INDESIT company

Model type:
AVTL62EU

Commercial code:
F033194

n1040345: Replacement of drum lock button TL EVOII.

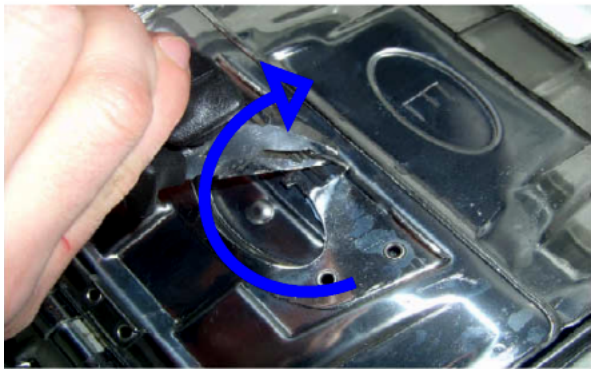
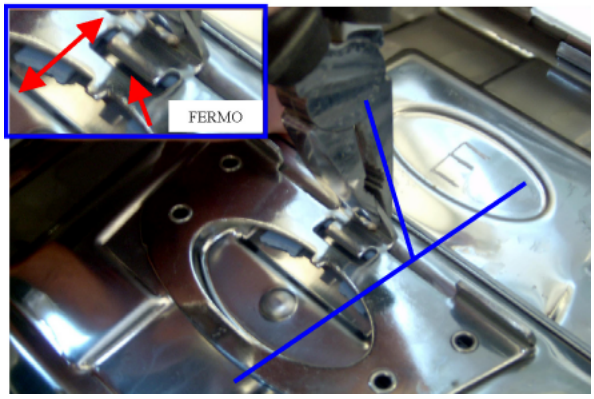
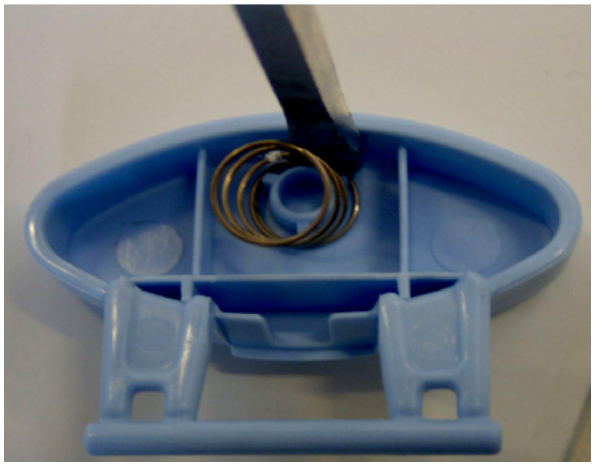
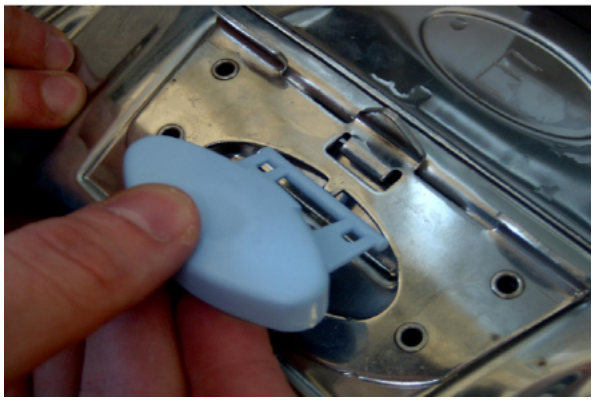
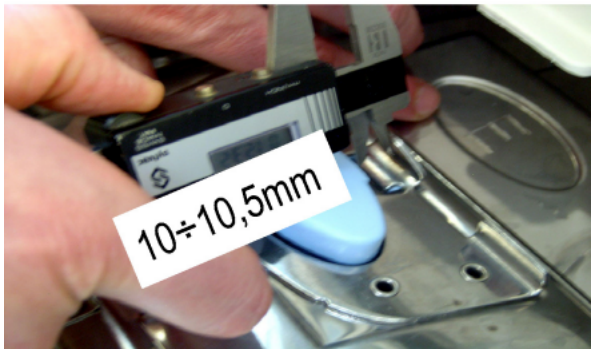
Tools and material needed: pliers, screwdriver, gauge, spring P/N Sat 114989, button P/N Sat 114990.

1) turn the central tip of the catch in the direction shown (FIG.1);

2) bring the tip to a vertical position and ensure that the broken button is disengaged from the catch restraint and can be removed (FIG.2);

3) remove the remaining part of the button with the aid of a screwdriver, taking care not to scratch the doors (FIG.3);

4) pre-assemble spring to button (FIG.4);

5) insert button between catch and door (FIG.5);

6) bring the button into position and arrange the spring in its location in the door (FIG.6);

7) turn the central tip of the catch in the direction shown to return it to its starting position (FIG.7);

8) check the distance between button and catch (FIG.8);

9) check correct operation of the button when opening and closing the doors (slight inclination errors of the catch can result in faulty closing of the doors) (FIG.9).

n1040382: Drain pump with bayonet-style filter - top Loading Brembate

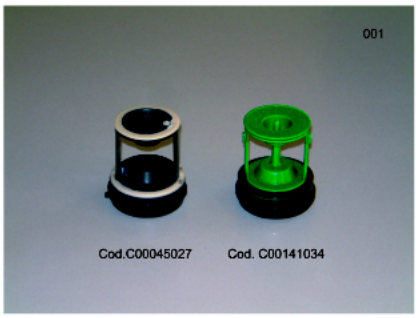
From serial no. 51021.0001 a new drain pump with bayonet-style filter has been installed on all top loading washing machines manufactured in Brembate.

New parts:
C00141862 - Drain pump
C00141034 - Pump filter kit

Premodification parts:
C00111409 - Drain pump
C00045027 - Pump filter kit

The new parts can be used instead of premodification ones.

N1040404FIG1

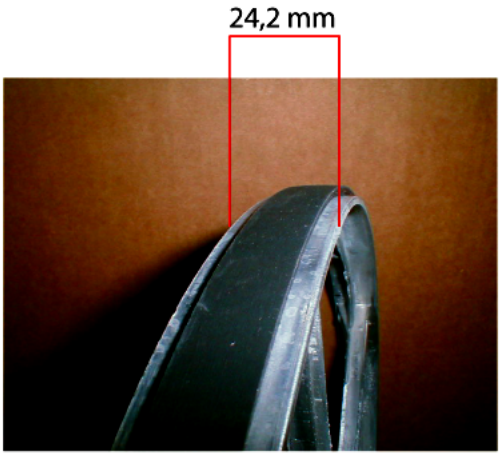
From serial no. 51202.0001 the pulley track has been widened from 21.2mm to 24.2mm (see picture N1040404FIG1).

new pulley
C00142832 - D280 24.2 mm track

Premodification pulley
C00083912 - D280 21.2 mm track

The new pulley can also be used on premodification versions of the models referred to in this release.
